## HEITMANN & ASSOCIATES, INC.

Curtain Wall Observation Report

6 November 2000

Project :	One World Trade Center New York, New York
Project Number:	20063.00
Observation Dates:	Various dates between September 13, 2000 and October 25, 2000
Report Prepared By:	William G. Young

5

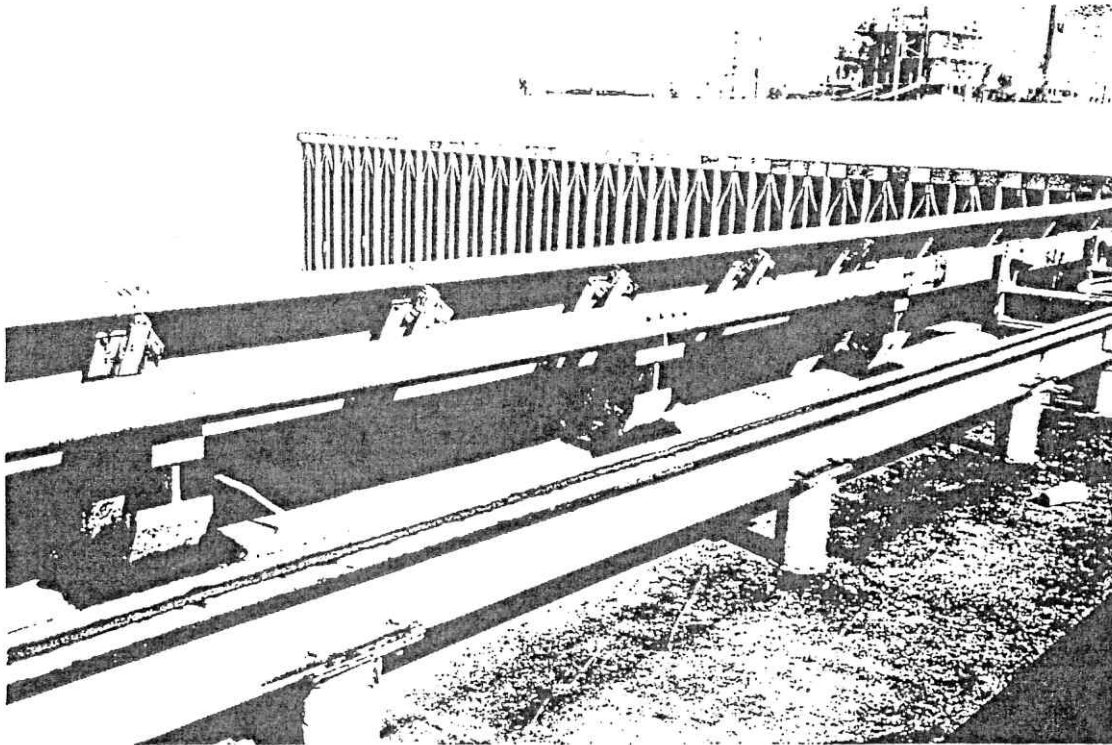
- E. The sloped parapet panels at the top of the tower are primarily decorative as the concrete slabs and roofing system below provide the main water barriers (Refer to photograph 5). The parapet panels are supported by steel framing anchored to the building the structure. The steel framing is exposed to the weather.

10

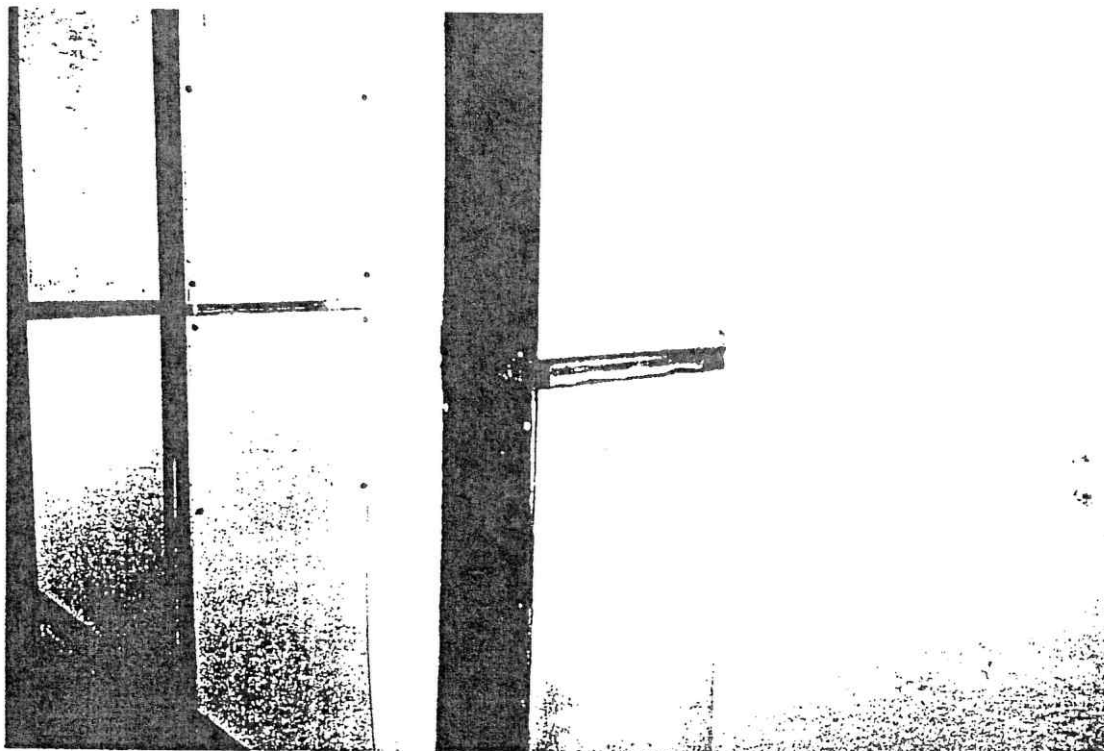
- a. In general the curtain wall system appears to be in good structural condition with no obvious signs of failure.
  - b. The condition of sealant joints visible at the setbacks varied from poor (sealant is dry and hard) to recently replaced (Refer to photograph 10). Replacement of sealants appears to have been done on a spot basis to address specific areas of failure or reports of water leakage. Additionally, joints that were intended in the original design to be left open have been sealed. The open joints are intended as a drainage path for water that enters the curtain wall system in the floor height above. If the system is functioning as designed, water should not be able to enter the open joints and reach the interior of the tower. However, if failure of internal seals or flashings prevents the system from functioning as designed, it may be necessary to seal the open joints to prevent water entry instead of dismantling the system. When sealing the open joints, caution must be exercised to prevent water being trapped within the curtain wall system.

4. Sealant joints - While the overall condition of the sealants is poor due to its age and type, actual failures are isolated. Thus, the sealant could continue to be addressed on an "as needed" basis or all sealants could be replaced as part of an overall remedial program.

13

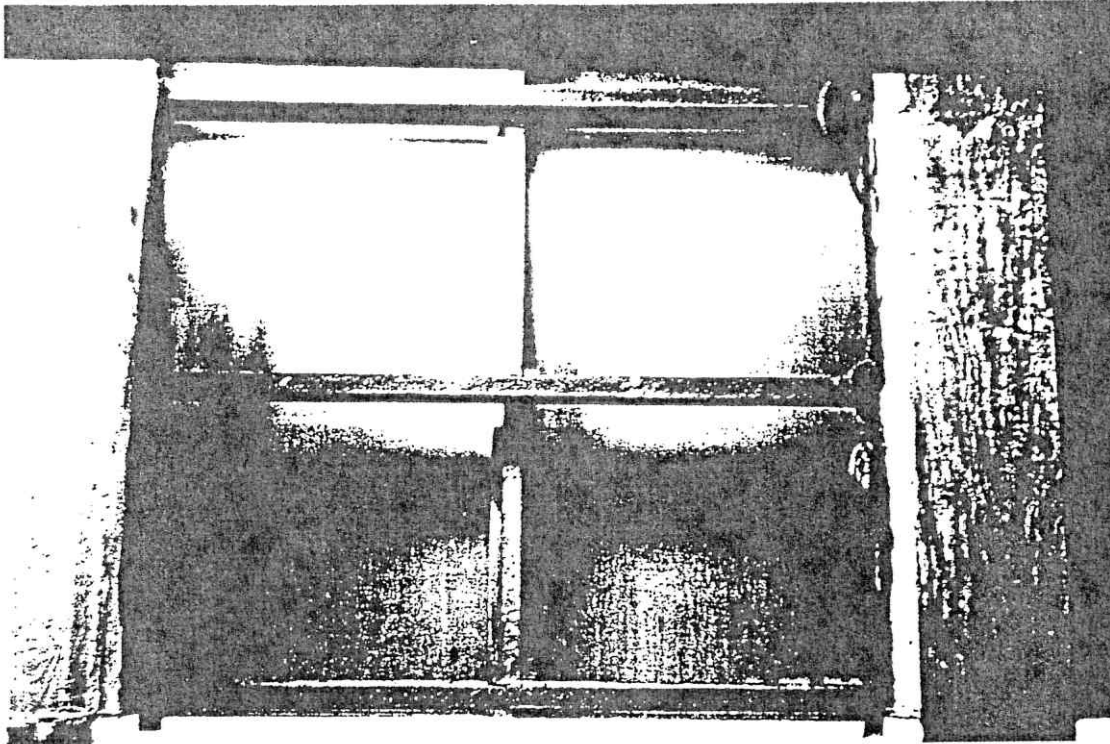
- d. From the roof level it was noted that the steel framing that supports the sloped parapet panels is lightly rusted (Refer to photographs 13 and 14). The base of the steel framing is supported on a pedestal that comes up from the building structure below. Steel shim plates used between the steel framing the pedestal to adjust the level are severely rusted (Refer to photograph 15).

6. Rusted steel framing - While the rusting of the steel framing for the sloped parapet panels is mild at this point, we recommend that the steel framing be cleaned, primed and painted to prevent further deterioration. The rusting of the steel shims is more severe and should also be addressed. The mild steel shims should be replaced with galvanized or stainless steel shims and the pedestals cleaned, primed and painted.
